DOCUMENT 00 90 00
ADDENDUM

ADDENDUM NO. [1]

Date: July 11, 2018

**RE: WISCONSIN INDIANHEAD TECHNICAL COLLEGE
WITC – BALSAM LAKE REGIONAL CENTER
INTERIOR REMODEL
HSR PROJECT NO. 17011**

2 RISER DIAGRAM

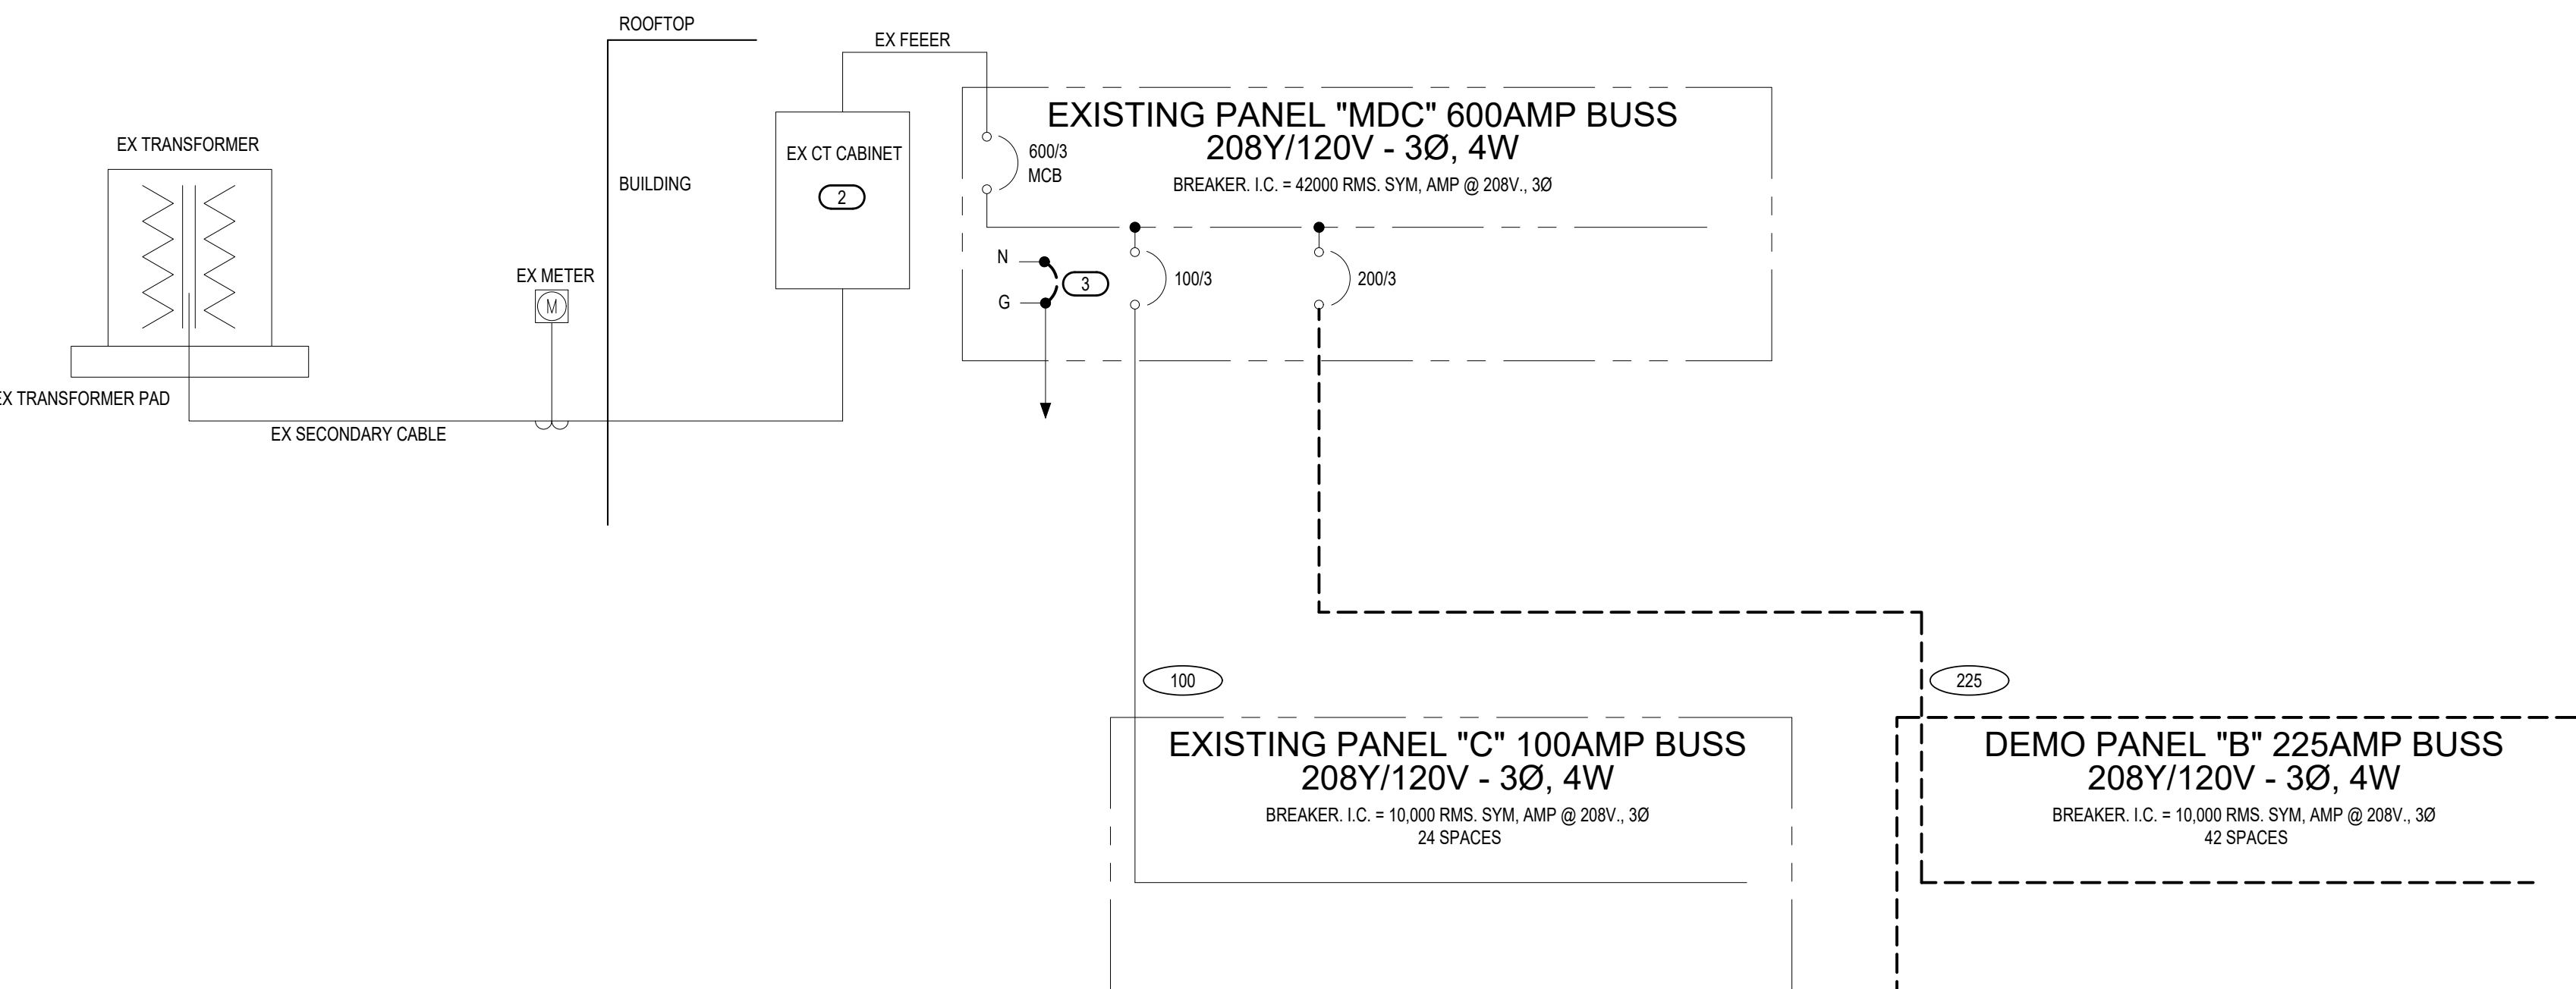
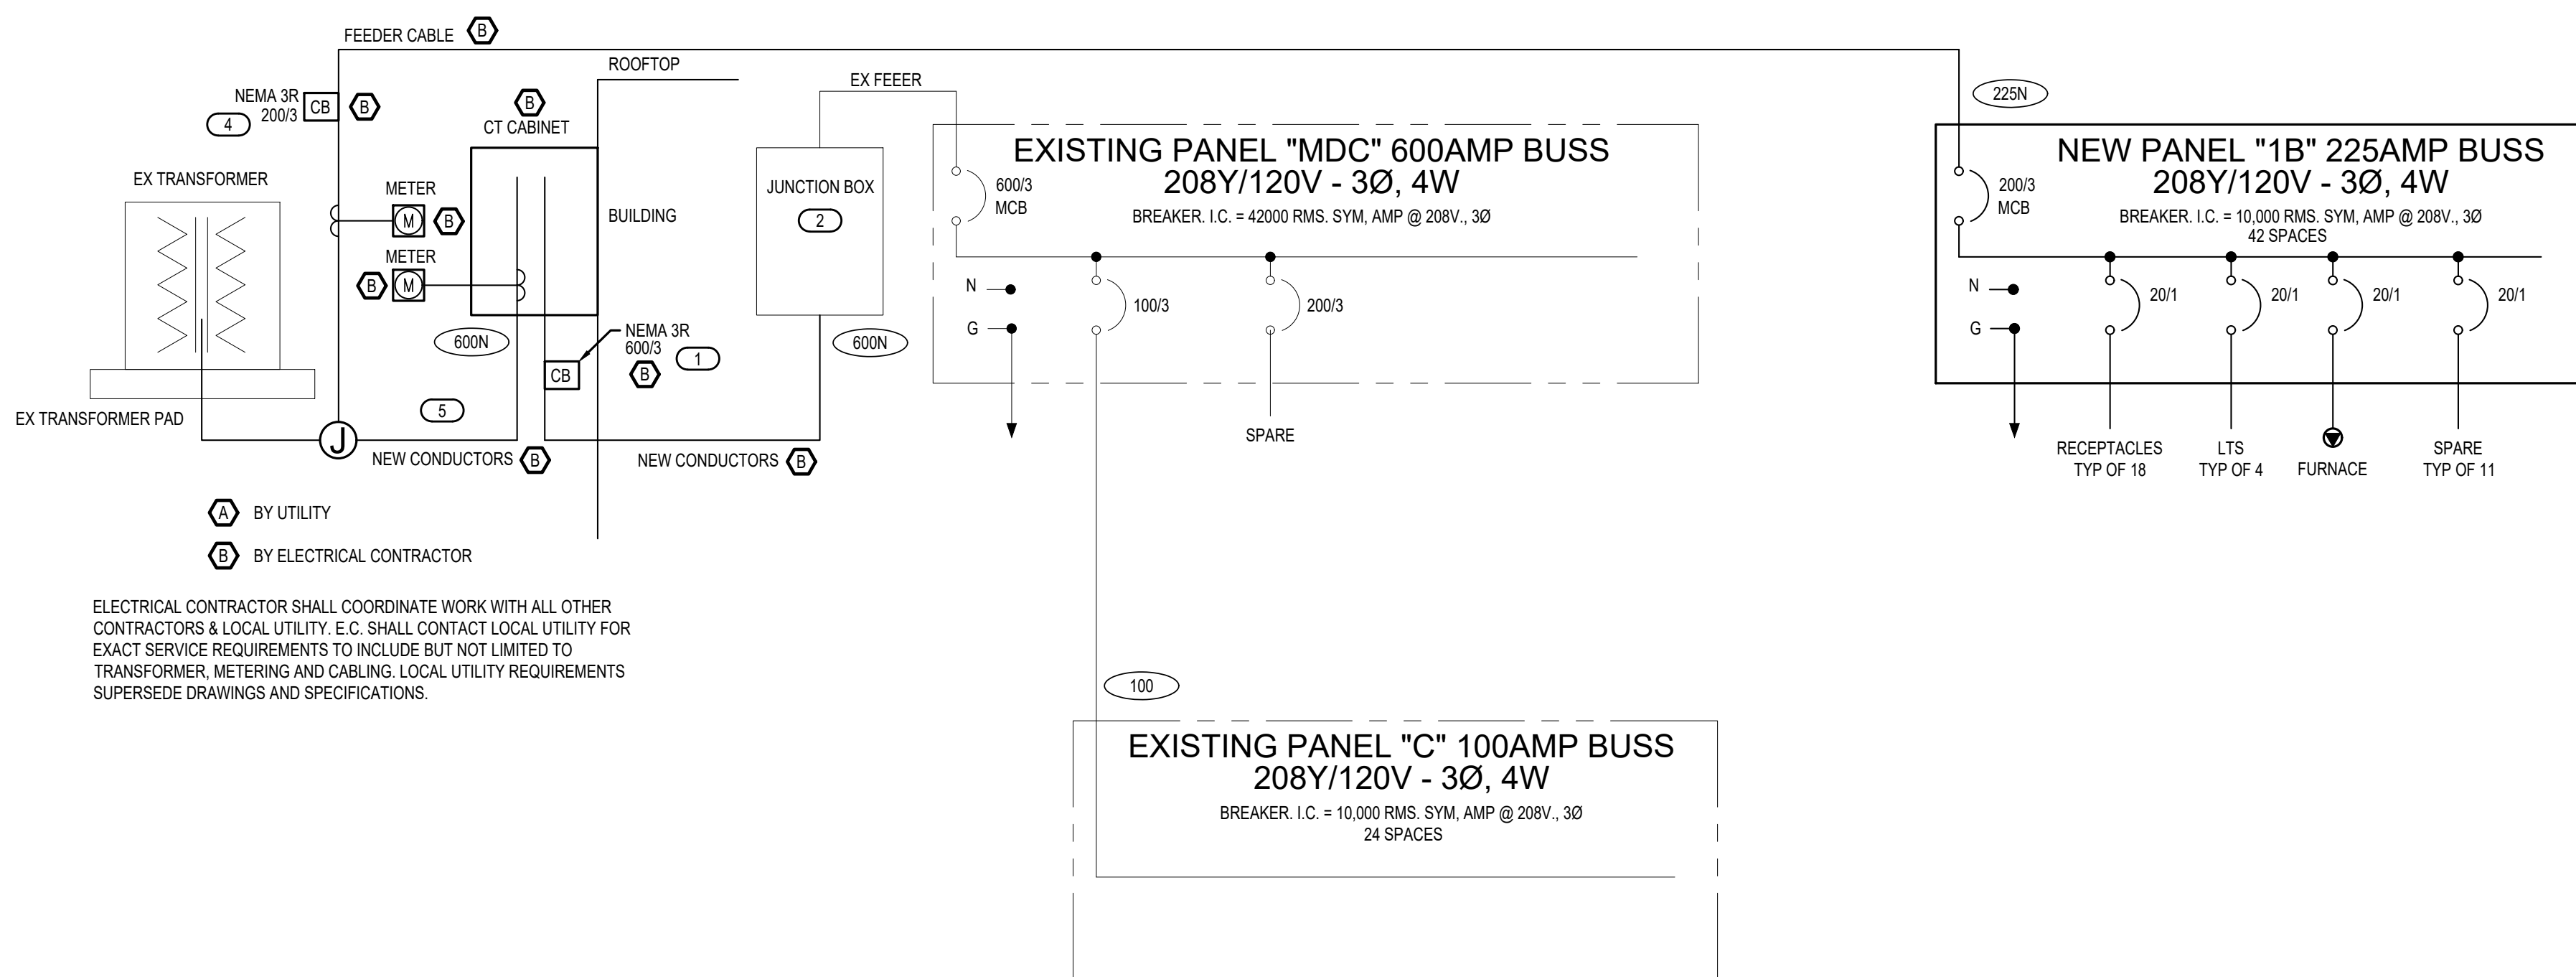
- a. Revisions as noted in the attached drawings.
 - i. Revise riser diagram as shown.
 - ii. Revise keyed note 1. Add keyed note 2, 3, 4, and 5.
13. Sheet MD101 MECHANICAL DEMOLITION PLAN

KEYED NOTES	
1	PROVIDE 20 AWG CU GROUNDING ELECTRODE TAP PER 250.64(D)(1) TO NEW GROUNDING ELECTRODE CONDUCTOR.
2	EXISTING CT CABINET TO REMAIN AS A JUNCTION BOX.
3	REMOVE NEUTRAL TO GROUND BOND.
4	PROVIDE #8 AWG CU GROUNDING ELECTRODE TAP PER 250.64(D)(1) TO NEW GROUNDING ELECTRODE CONDUCTOR.
5	PROVIDE 20 AWG CU GROUNDING ELECTRODE CONDUCTOR, CONNECT GROUNDING ELECTRODE TAP CONDUCTORS PER 250.64(D)(1).
